# **BEAN BLOSSOM LOT X**

## **APPEAL OF PLANNING COMMISSION DENIAL OF RESIDENCE**

**08APL-00000-00040, 08APL-00000-00041**

**Board of Supervisors**

# HILLSIDE/WATERSHED ISSUES BUILDING ELEVATIONS

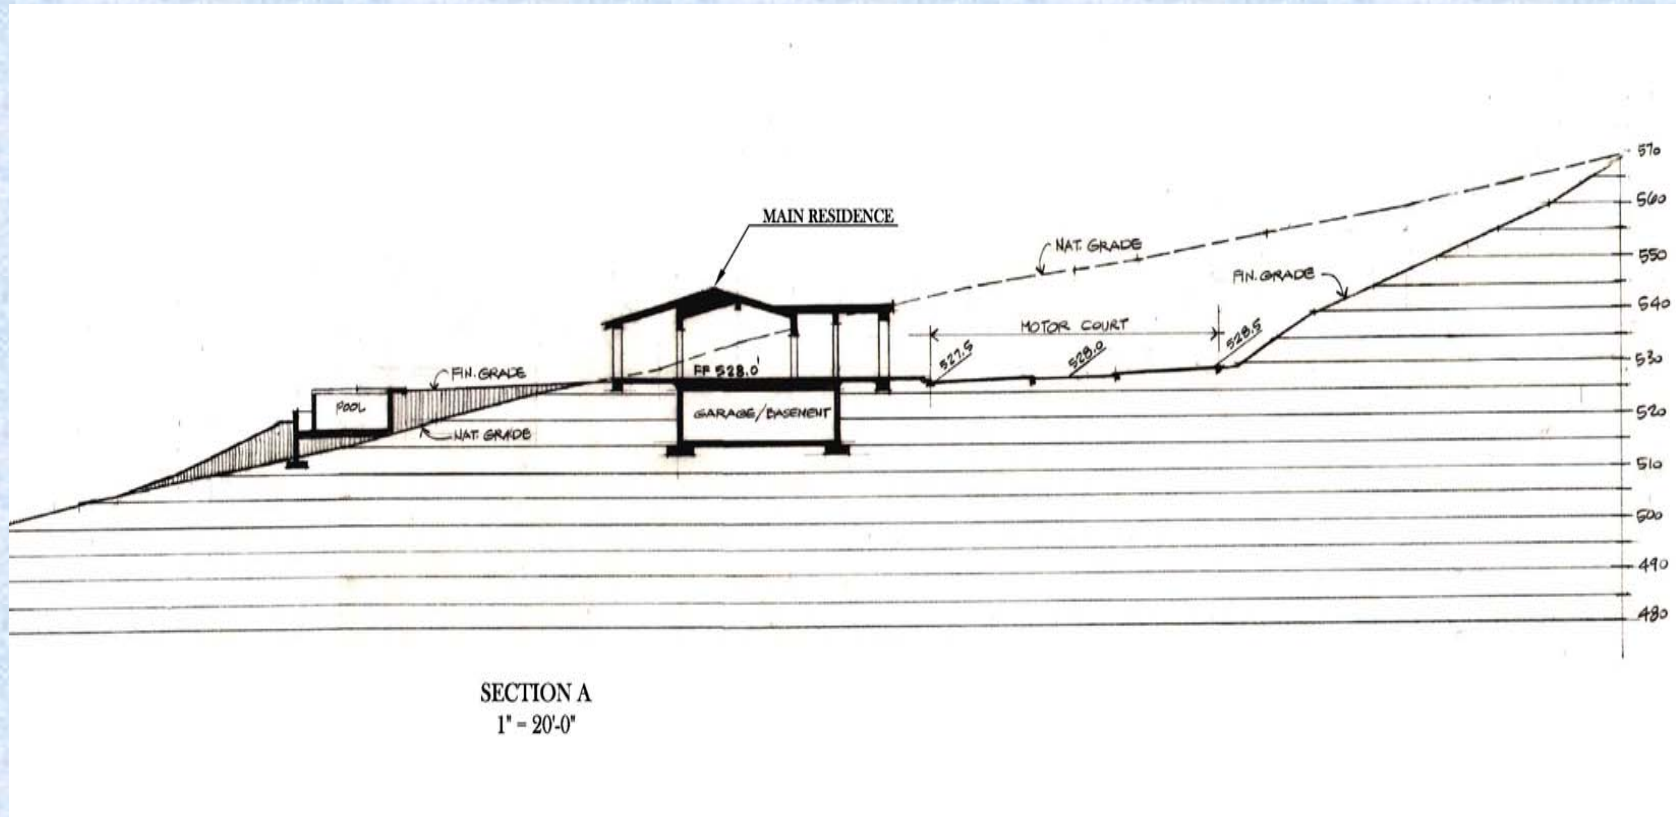
- **West Elevation Intrudes into Skyline**
- **Proposed Berm would Screen Residence**
- **Berm Inconsistent with Visual and Hillside/Watershed Policies**

**Residence must be Sited so as not to intrude into Skyline**

**Berm Requires Additional Grading**

# GAVIOTA COAST PROJECTS GRADING ESTIMATES

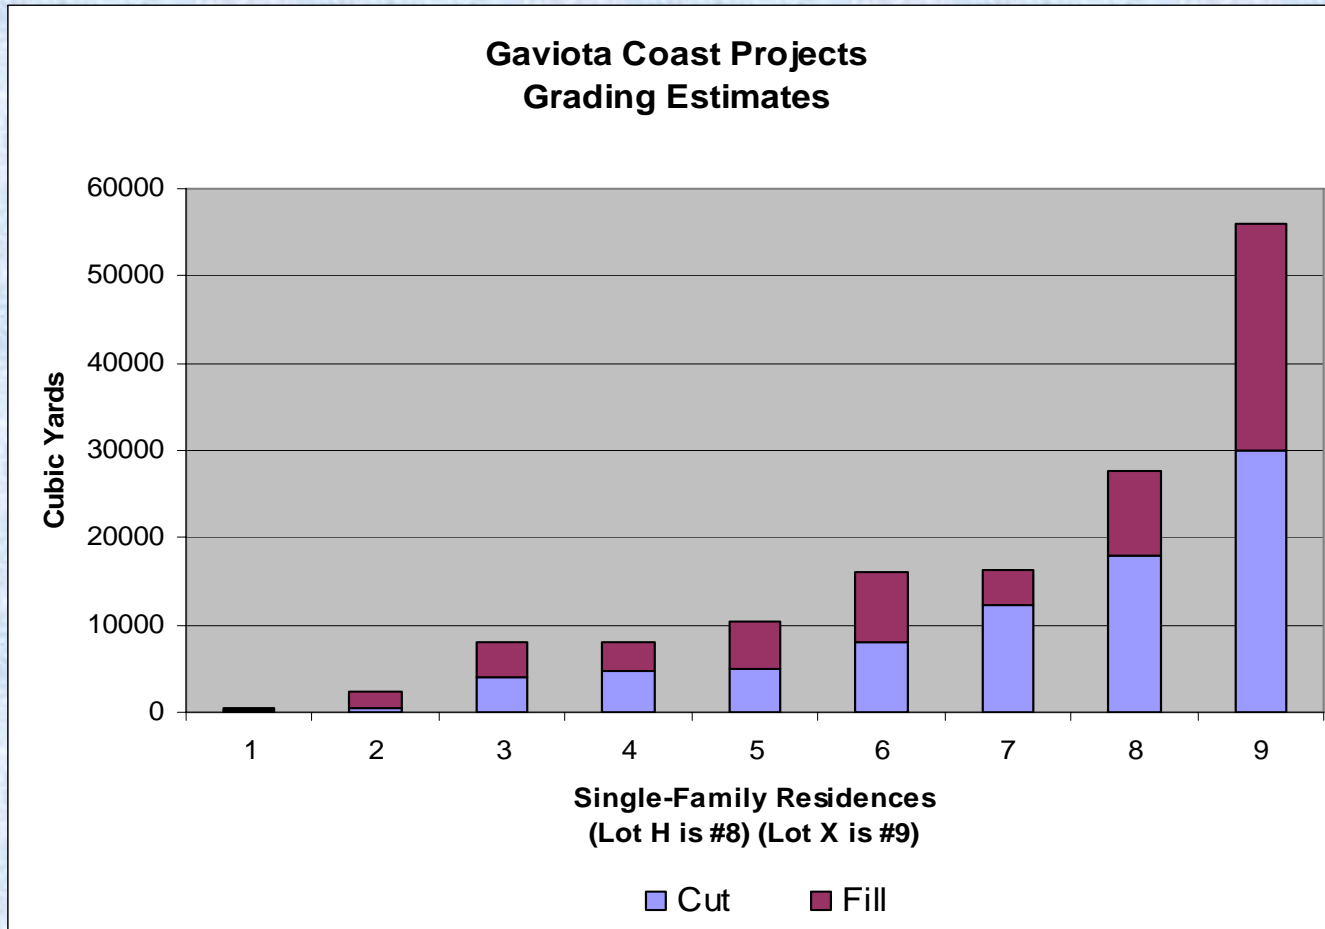
- **Residence, Guest House, Driveway**  
18,944 Sq. Ft. Residence and Guest House  
56,000 Cubic Yards Cut/Fill
- **Hillside/Watershed and Visual Issues**  
Excessive Grading, Alteration of Terrain  
Intrudes into Skyline
- **BAR Issues**  
Excessive Grading  
Incompatible Landscaping
